**THE NETWORK RAIL  
(SUFFOLK  
LEVEL CROSSING REDUCTION)  
ORDER**

**REBUTTAL  
PROOF OF EVIDENCE**

**S02 BRANTHAM HIGH BRIDGE**

Document Reference	NR/32/4/4
--------------------	-----------

PROPOSED ROUTE LIDAR

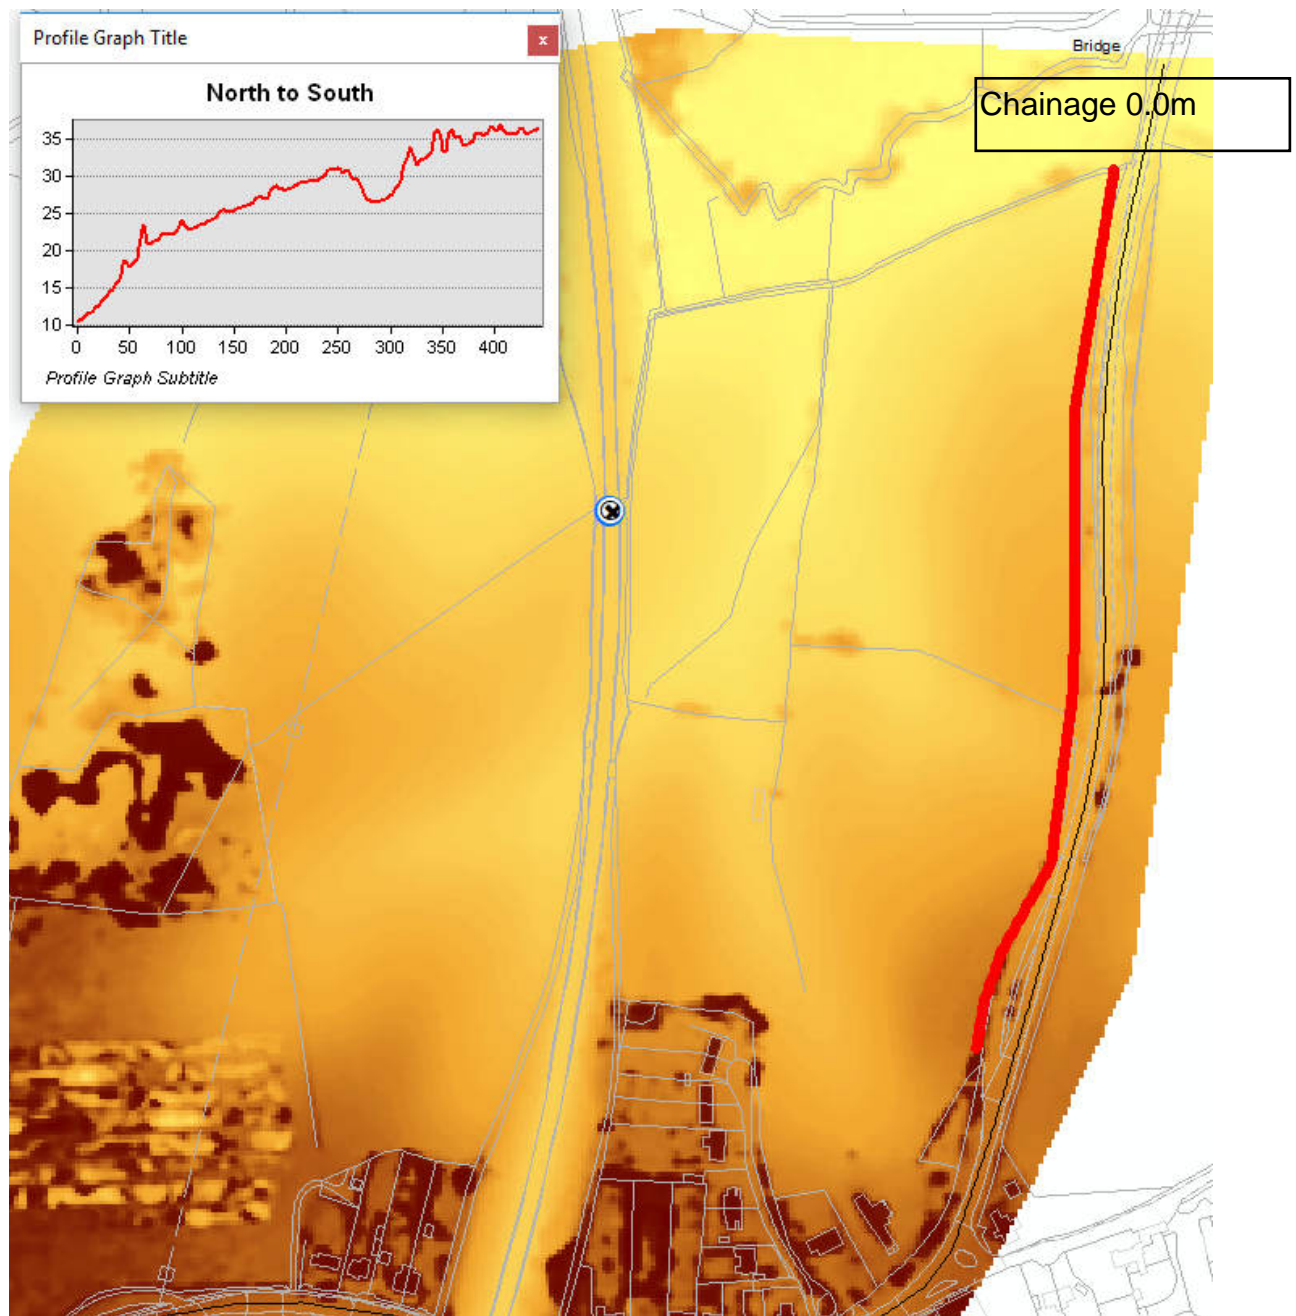
2.2.1 *At paragraph 10 of her Proof of Evidence (Obj 29/W3/S02), Annette Robinson states “the proposed route is sloping and has a crossfall making it inconvenient for use”*

2.2.2 In response, it is noted that the existing footpath to the east of the railway has to negotiate a steeply sloping embankment using uneven steps to reach the level crossing. LIDAR level checks on this area have been undertaken and the slope of this area is considered to be approximately 10% (1:10).

2.2.3 The LIDAR level checks show the gradients of the proposed route to be in the order of 8.5% (approximately 1:12) which is considered to be broadly comparable with sections of the existing public right of way route.

2.2.4 LIDAR output is shown in Appendix A of this rebuttal.
